DEPARTMENT OF NATURAL RESOURCES  
DIVISION OF OIL, GAS AND MINING

July 17, 1991

Re: Permit Status, Gardner Canyon Gypsum Mine, M/023/015, Juab County, Utah

Digitized Area = 22.52 ac  
Perimeter = 1.51 mi  
Shaded Area digitized  
Scale = 1" = 300'

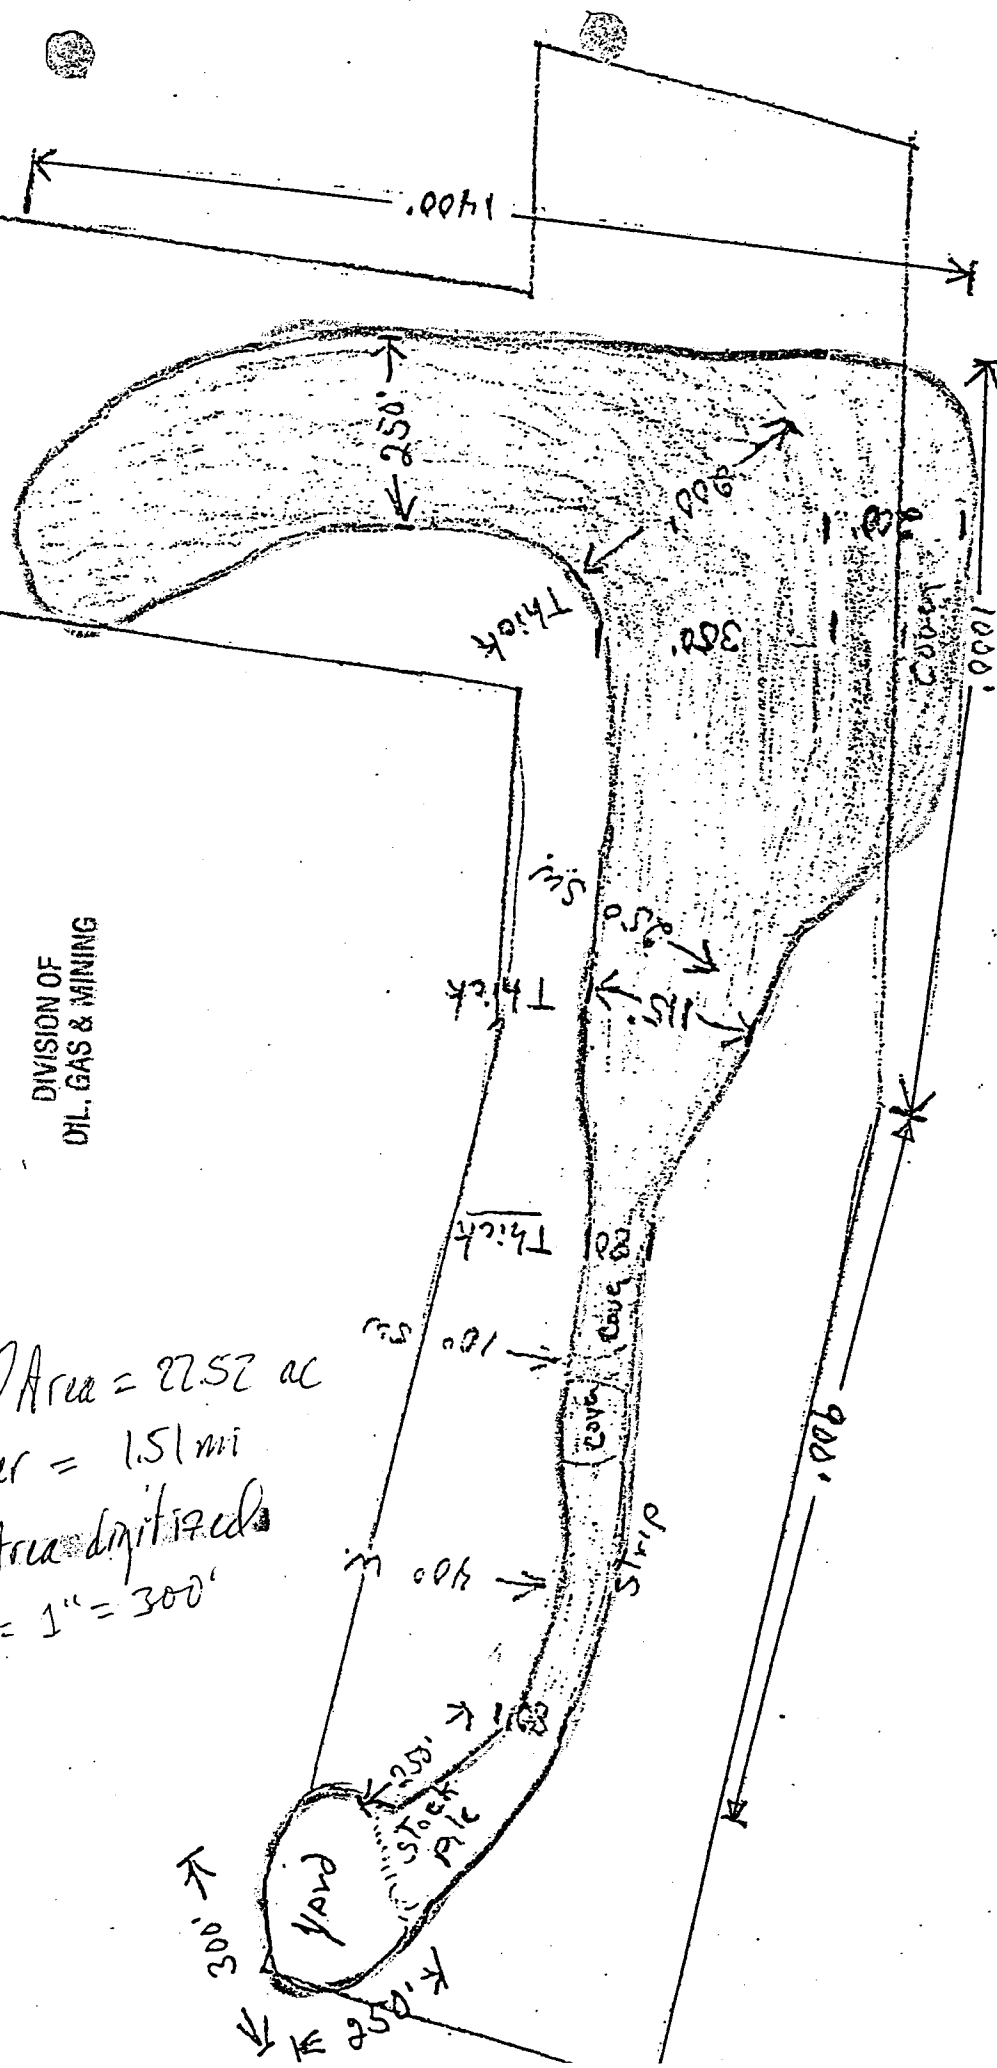
2. The Division has reevaluated the maps/drawings as provided with your USFS "Plan of Operations" application. We have digitized the area identified to be disturbed by your mining operation on a map entitled, "Surface Dimensional Map" and came up with a total of 22.5 acres (not including the access road). In addition a portion of the area to be mined appears to extend outside of the claim boundary as presently drawn on your map (copy attached).

Your USFS Special Use Application identifies an additional 2.5 acres of proposed disturbance to be associated with the upgrading of the Gardner Canyon mine access road (within USFS Wilderness Area). This brings the total projected surface disturbance to 25 acres. Based upon these figures, the Division cannot accept your small mine permit application request. A large mine permit application would be required.

The Division cannot continue to process your mining application as a small mining operation until you can provide supplemental information to support this request as previously outlined in our July 11, 1991 letter. I trust this will help clarify our position on this permitting action and answer your concerns as discussed during our conversation on July 16, 1991.
